**MOUNT POLLEY MINING CORPORATION
MOUNT POLLEY MINE**

**TAILINGS STORAGE FACILITY
REPORT ON 2005 ANNUAL INSPECTION
(REF. NO. VA101-01/11-1)**

Rev. No.	Revision	Date	Approved
Rev 0	Issued in Final	May 3, 2006	K.I.B.

Knight Piésold Ltd.

PHOTO 10: Perimeter Embankment. Confining berm used for the construction of the Zone U section using coarse tailings sand.

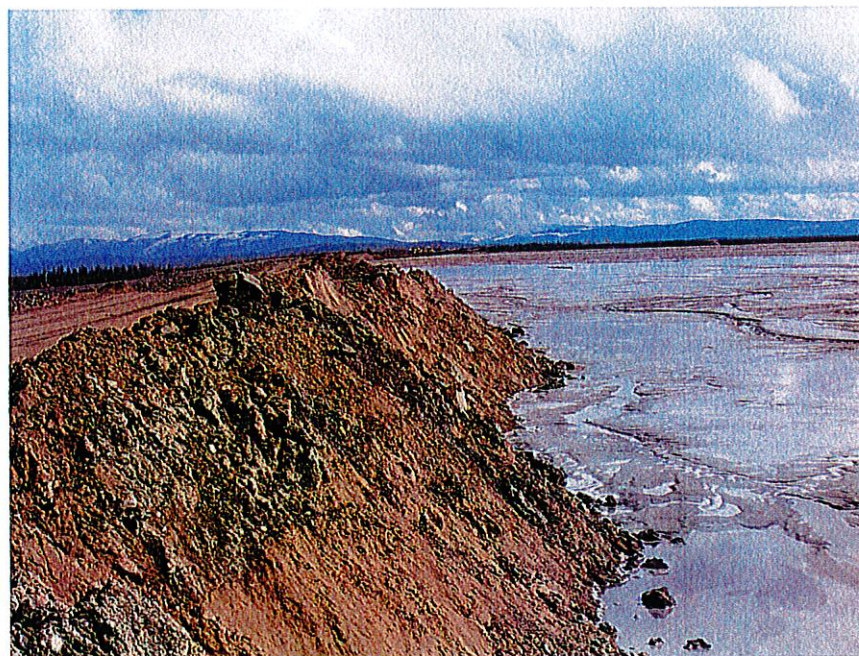
No major unexpected or uncontrolled seepage was observed from the embankments. The small amount of seepage observed at the base of the Perimeter Embankment between chainages 29+00 to 32+00 is being routed to the Perimeter Embankment Seepage Collection Pond.

PHOTO 13: Main Embankment with the tailings pond up against the Zone U material.

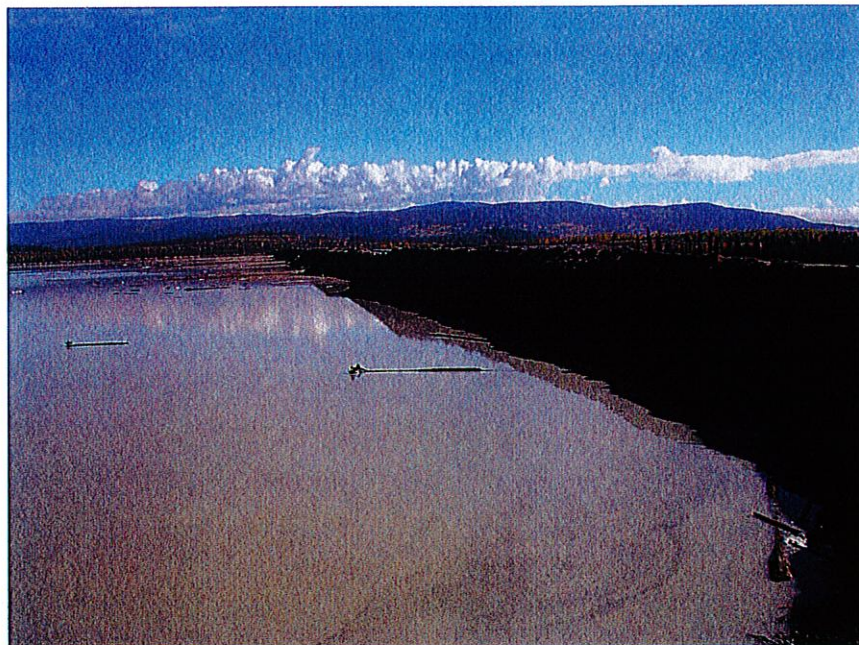
The Tailings Pond is adjacent to the Main Embankment (app. chainage 16+00 to 19+00). This was the result of prolonged discharge of tailings from the Perimeter Embankment and from the knife gate valve.

- Develop a tailings deposition plan that involves discharging tailings from the Perimeter, Main, and South Embankments. Discharging tailings from around the facility will facilitate the development of tailings beaches and help in the management and location of the tailings pond. The tailings pipeline should be extended to the South Embankment in 2006 to allow for beach development at the South Embankment.
